The Town of Hilton Head Island
Design Review Board Regular Meeting
Tuesday, October 8, 2019 – 1:15 p.m.
Benjamin M. Racusin Council Chambers
AGENDA

Town of Hilton Head Island
Design Review Board

8 Office Way Restaurant Project Narrative:

Paint Scheme

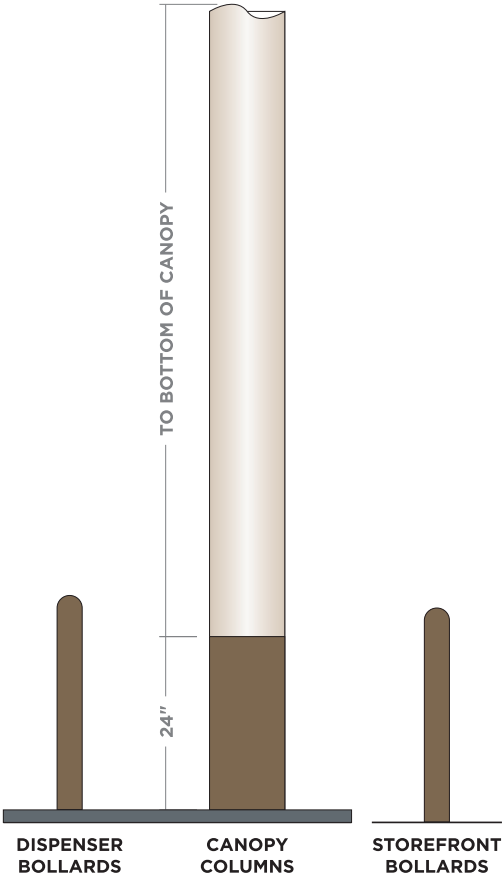
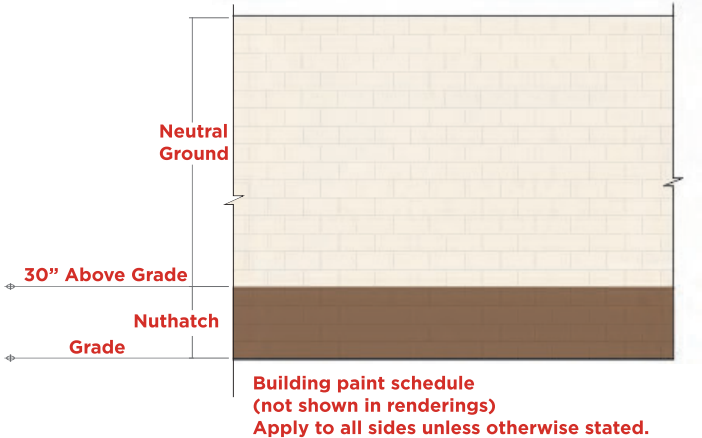
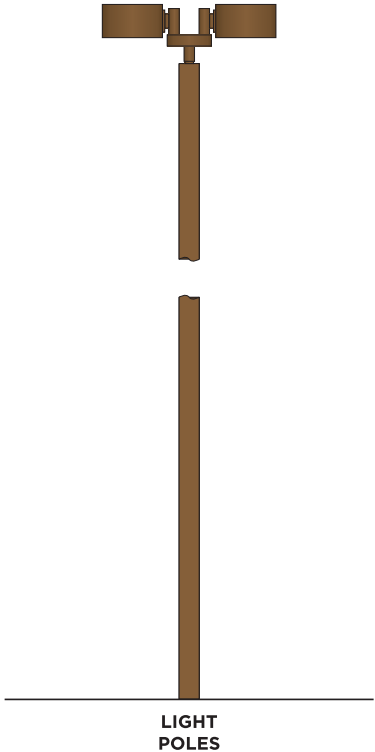
9. Any additional Signage shall have a brown background with beige lettering.
10. ~~Mark through the "Standard Fascia" detail on Circle K Paint Specifications sheet as not included in this project.~~

11. ~~Mark through the "Building Paint Schedule" detail on Circle K Paint Specifications sheet as not included in this project.~~

9. It is unclear where the fascia detail is proposed to go on the building. It is Staff's understanding that the "Standard Fascia" detail on Circle K Paint Specifications sheet is not included in this project. This detail must be marked through to delete it from the application.

10. It is Staff's understanding that the building will not be painted. The "Building Paint Schedule" must be marked through to delete it from the application.

LOGGIA PLAN
SCALE: 1/4" = 1'-0"

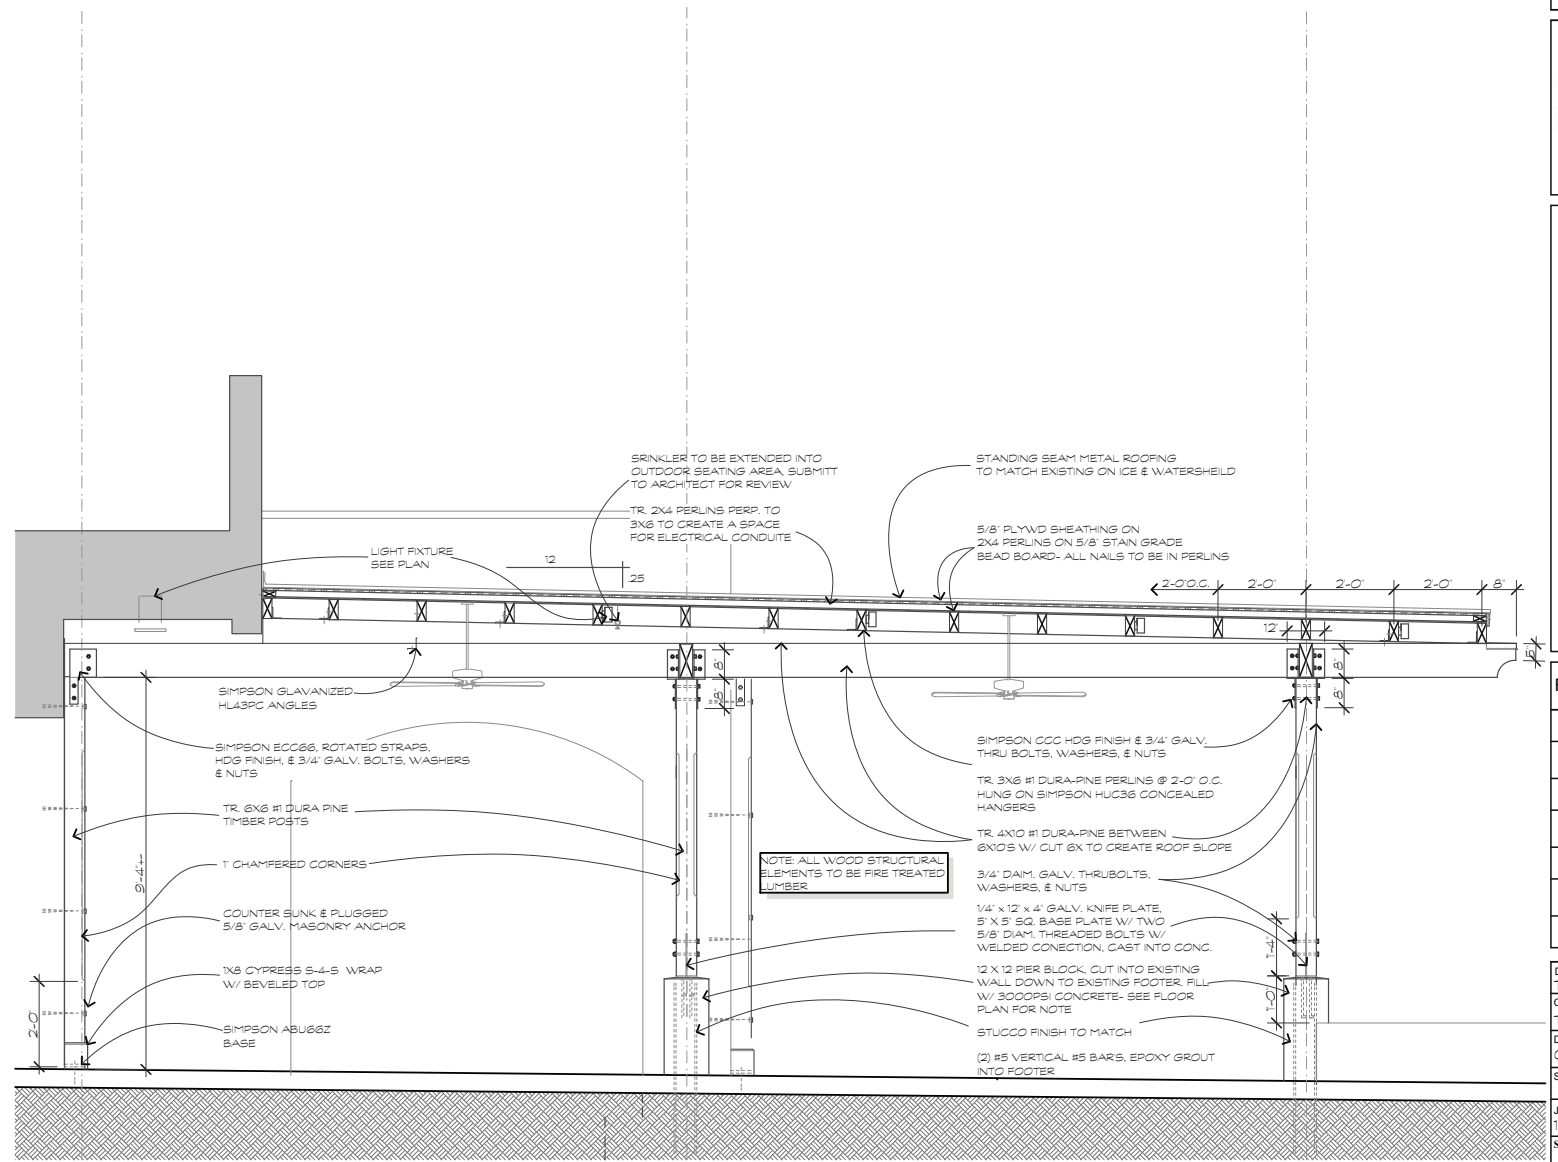
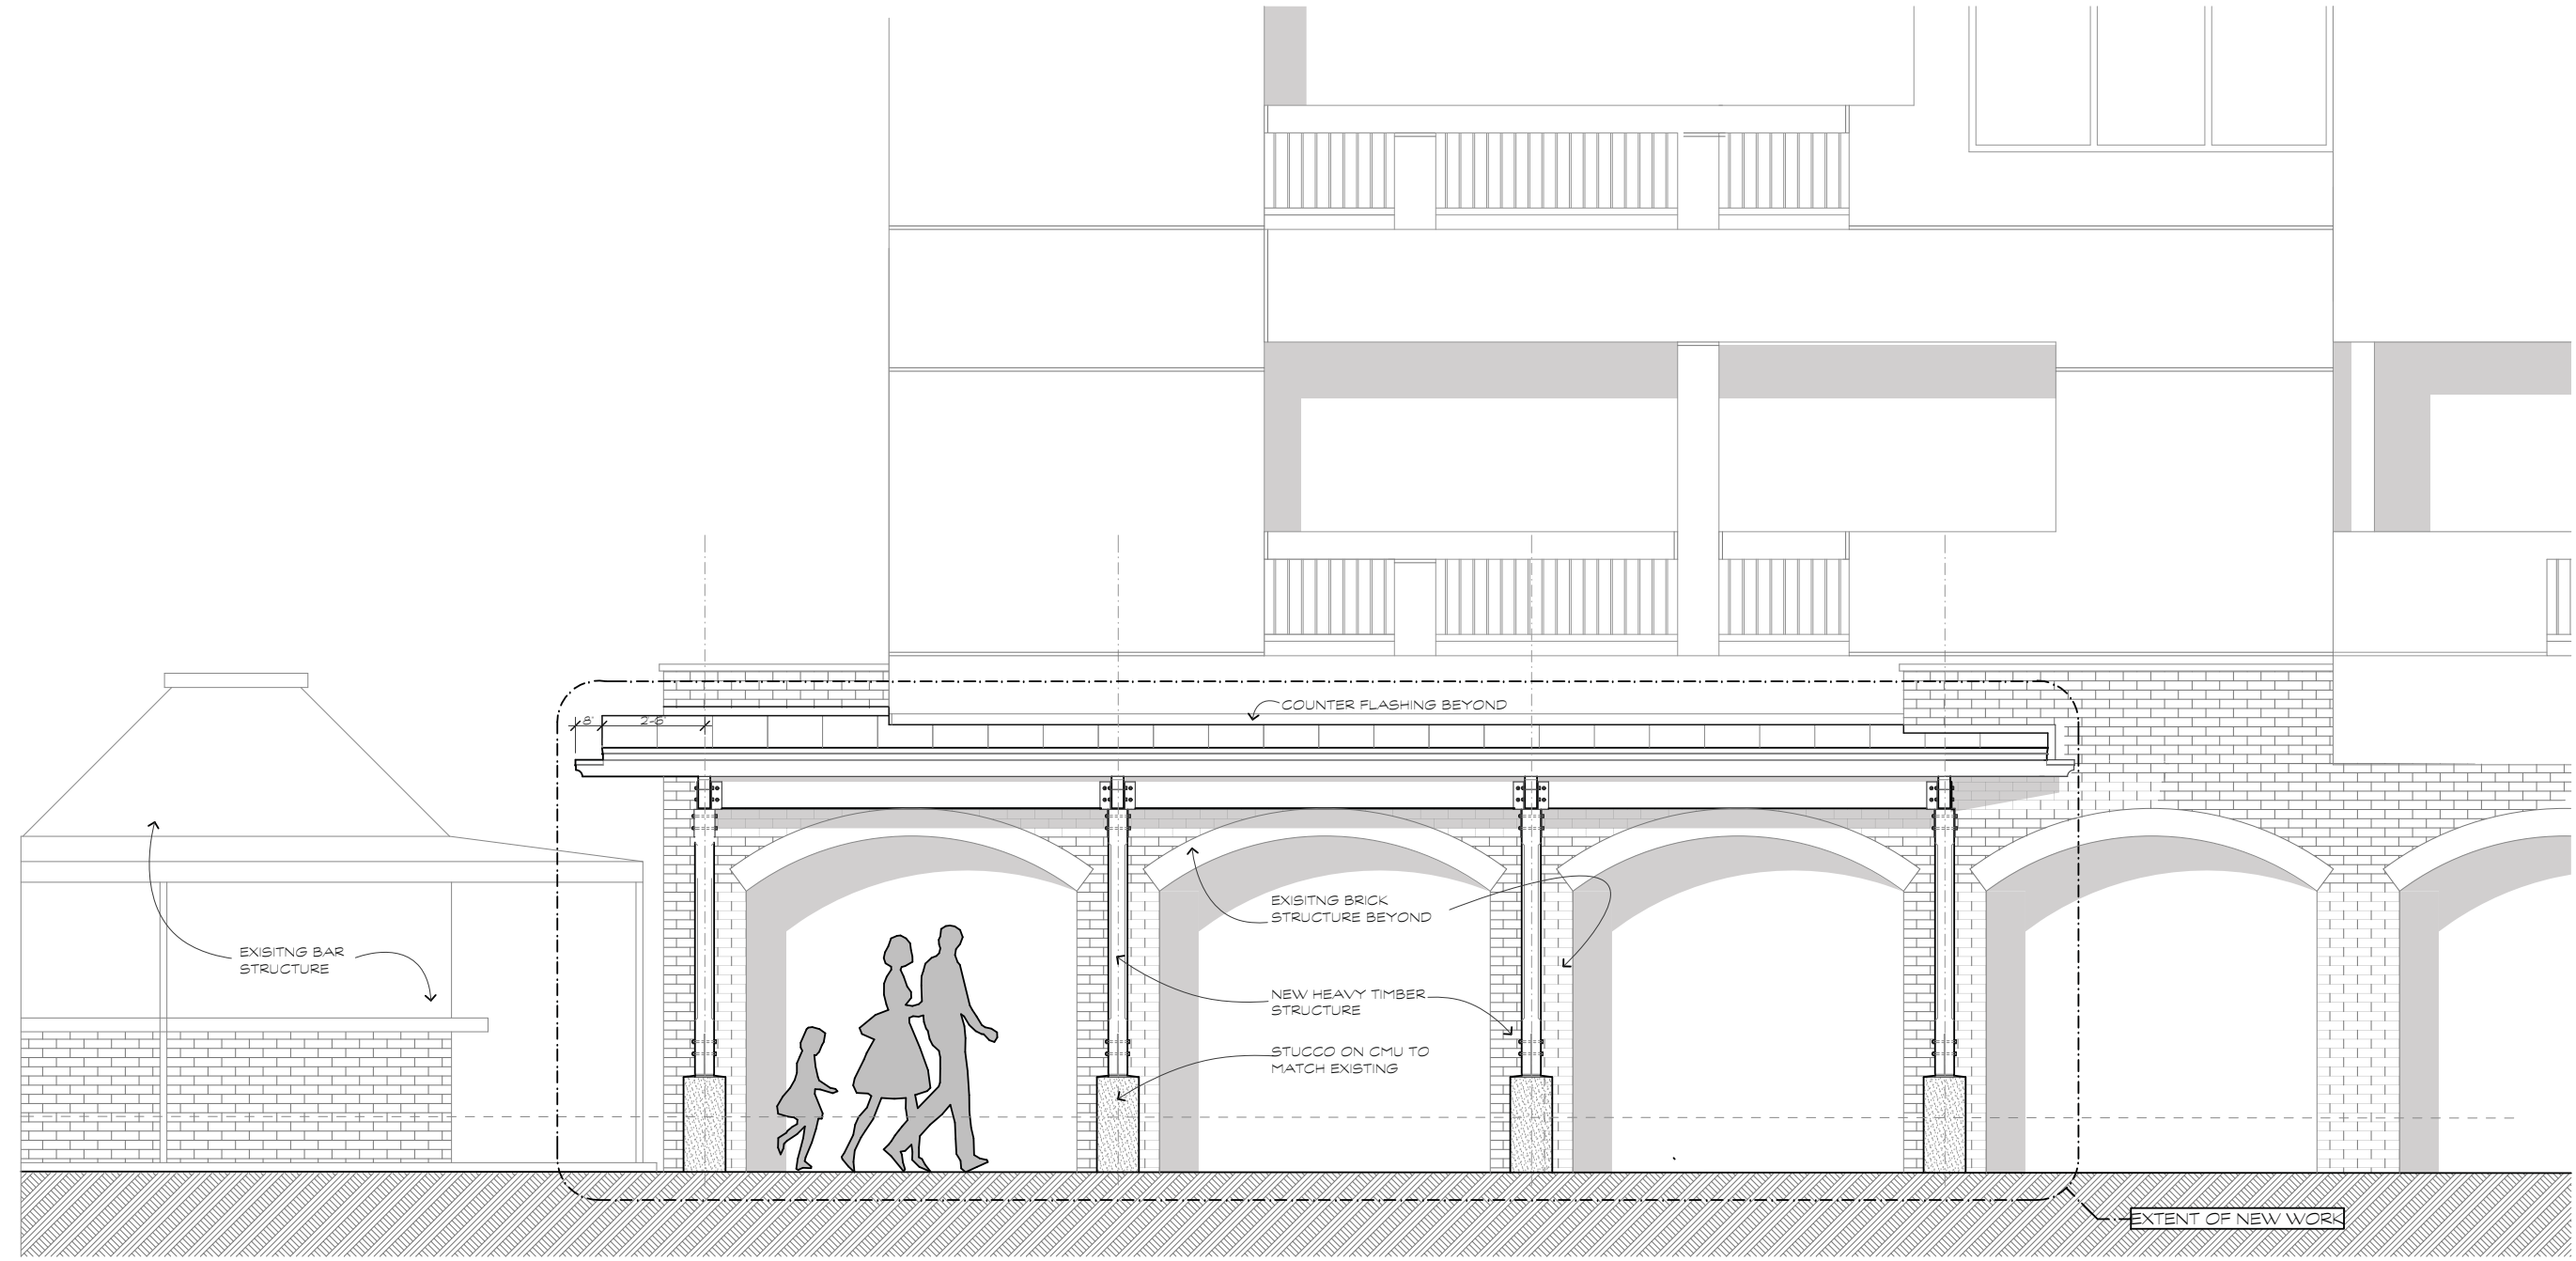
1. Specify on the drawings that the structure will be stained to match the existing patio structures.
2. Note on the plans that all electrical conduit must be concealed.
3. Provide a cut sheet for the light fixtures that meets the LMO lighting requirements and does not exceed 3000 K

DESIGN GUIDE/LMO CRITERIA	Complies Yes	No	Not Applicable	Comments or Conditions
Utilizes natural materials and colors	<input type="checkbox"/>	<input checked="" type="checkbox"/>	<input type="checkbox"/>	Please label on the plans, stain to match existing covered patio structures.
Minimum roof pitch of 6/12	<input type="checkbox"/>	<input checked="" type="checkbox"/>	<input type="checkbox"/>	
Utilities and equipment are concealed from view	<input type="checkbox"/>	<input checked="" type="checkbox"/>	<input type="checkbox"/>	Note on the plans that all electrical conduit shall be concealed.
Decorative lighting is limited and low wattage and adds to the visual character	<input type="checkbox"/>	<input checked="" type="checkbox"/>	<input type="checkbox"/>	The specifications for the LED fixtures is not clear on the drawings. LED lights should not exceed 3000 kelvin and meet the LMO brightness requirements.

Proposed Sign

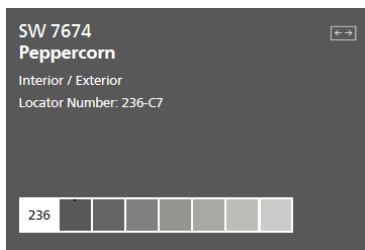
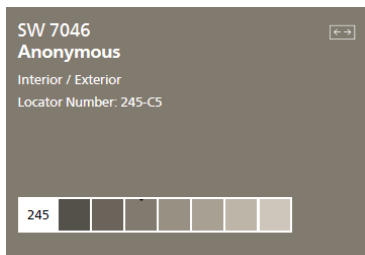
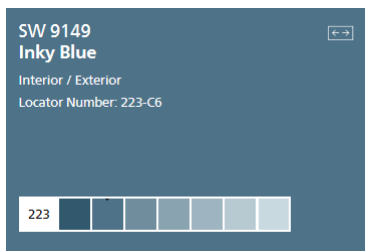
REQUIRED INFORMATION & DESIGN STANDARDS	Yes	No	N/A	Comments & Questions
Colors reflect/complement the colors on the building walls, trim, etc.		X		The logo color is not a color used for any other architectural features on the site.
